**ADDENDUM NUMBER TWO (2)  
TO THE PLANS AND SPECIFICATIONS FOR:**

**NORTH ECHS  
AND  
COLLEGE & UNIVERSITY CAMPUS  
STUDENT RESTROOM RENOVATIONS**

**PSJA ISD  
Bid # 18-19-042  
Project No. 19.04**

**GIGNAC & ASSOCIATES  
3700 N. 10<sup>th</sup> STREET, SUITE 205  
McALLEN, TEXAS 78501  
(956) 686-0100**

1 ENLARGED FLOORPLAN — BUILDING S  
1/4" = 1'-0"

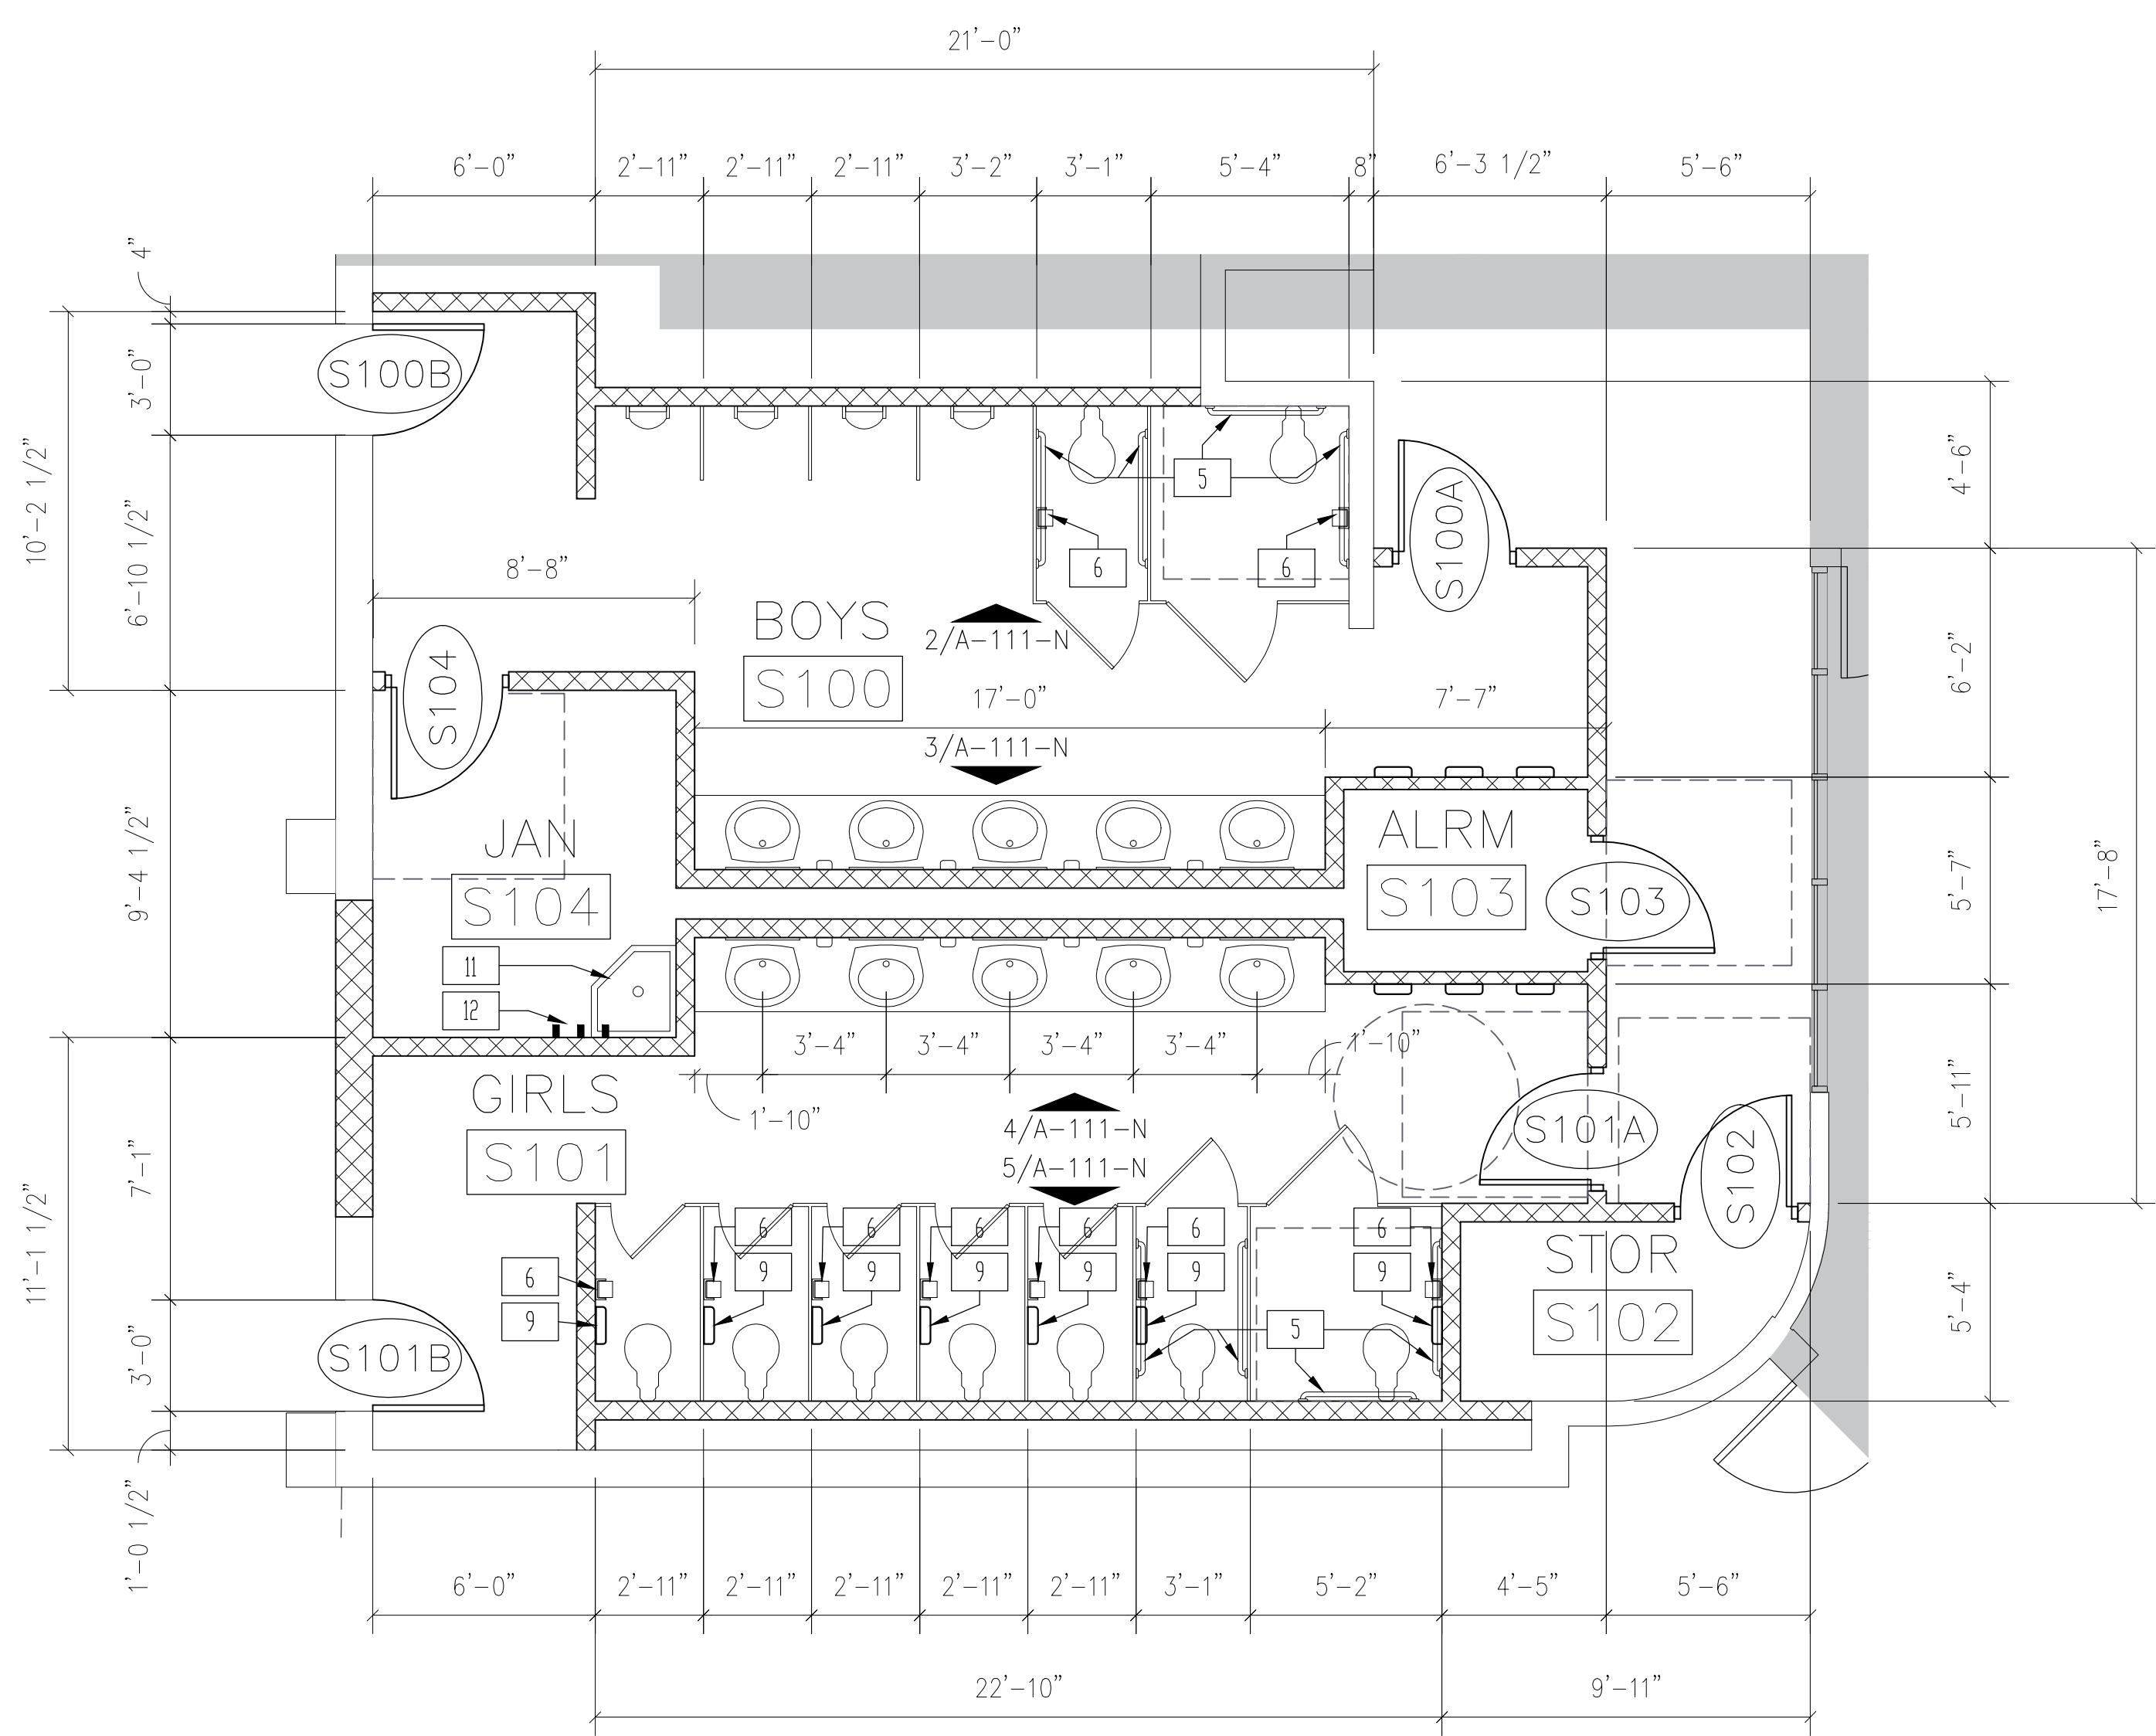
Sheets A-110-N thru A-127-N included in this Addendum shall replace their respective sheets in the Contract Documents. Further labeling, dimensions, and clarification was added.
